**CITY OF MANHATTAN BEACH
DEPARTMENT OF COMMUNITY DEVELOPMENT**

DATE: July 26, 2012

SUBJECT: Consideration of an Encroachment Permit Appeal to Approve a Raised Yard in the Public Right-of-Way – 519 21st Street

SHEET TITLE:
ENCROACHMENT PLANS

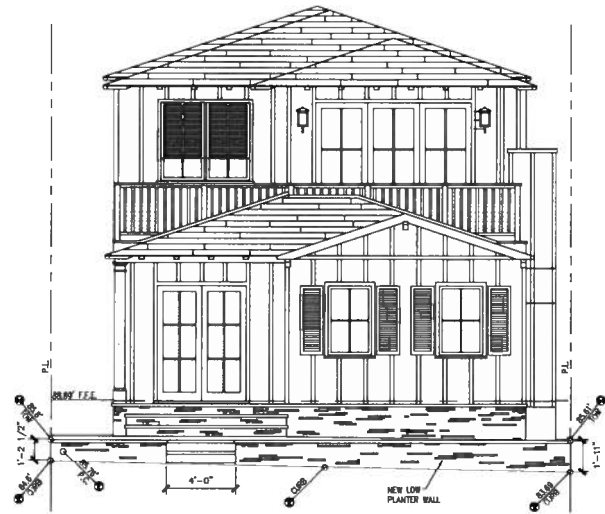
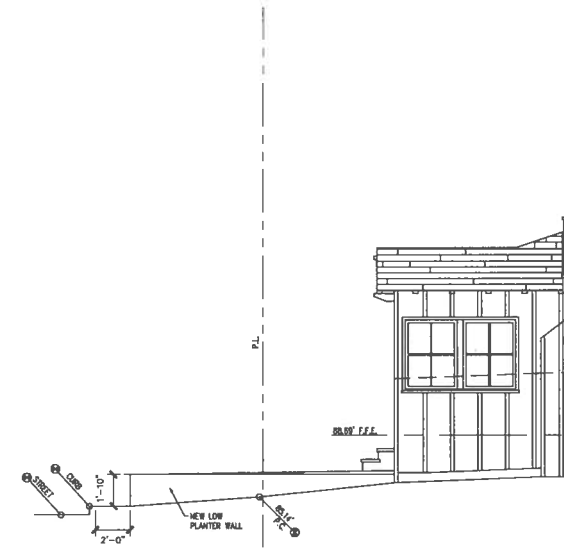
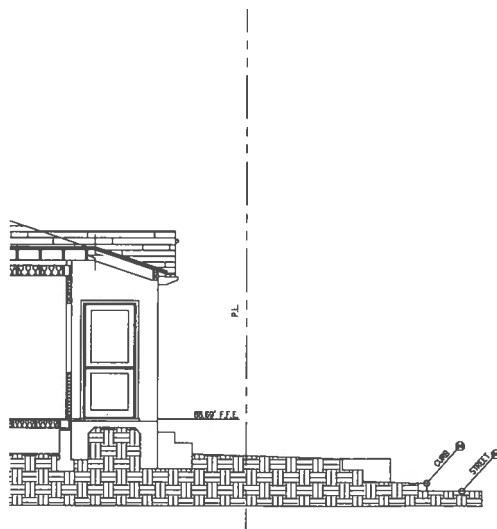
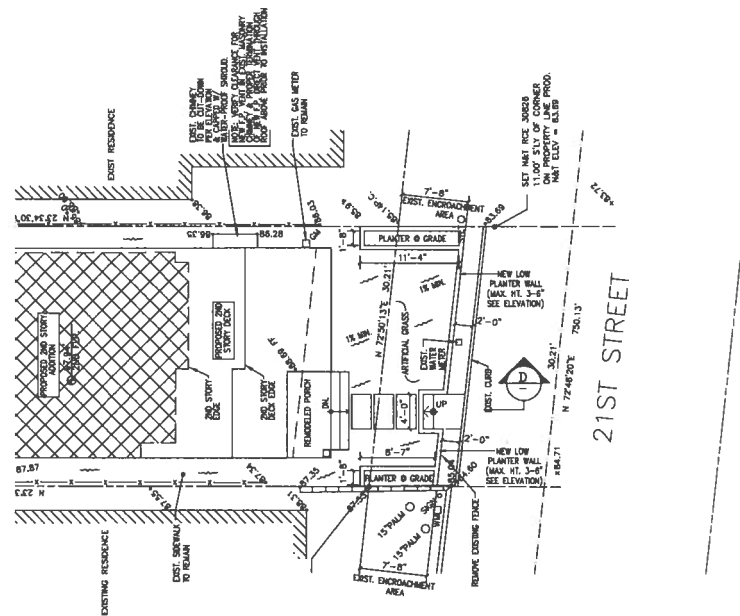
The submitted appeal plan shows a new concrete wall, as much as 2 feet tall, supporting a raised front yard extending into the site's existing mildly sloped encroachment area (currently unused public right-of-way) with an entry walkway, including one step, toward the west side leading to the house. Section 7.36.150 of the Municipal Code permits fences and walls in encroachment areas at a maximum height of 3.5 feet in these areas, but does not permit changing the grade in drive-street encroachment areas (unlike walk-streets). This precludes the possibility of significantly raised grade for leveling-off the applicant's encroachment area. The plan does provide the required 2-foot clearance from the street curb to the proposed wall.

Municipal Code Section 7.36.150 (D) states that "Significant alteration of the existing right of way grade is prohibited, unless determined to be necessary to accommodate a required public street improvement". Staff's understanding of the purpose of this requirement is to keep drive-street right-of-way in a manageable condition for future City street work, and to limit private reliance on public property.

Staff does not support the request for the raised right-of-way grade and retaining wall because it is not consistent with the encroachment standards described above, and recommends that the PPIC recommend denial of the Encroachment Appeal request to the City Council.

Should the PPIC recommend approval of the raised grade, staff suggests conditions be imposed requiring restoration of the original grade, and removal of the retaining wall, whenever the existing building is demolished in the future, and that any City costs (future street work) that may result from the retaining wall be paid by the property owner.
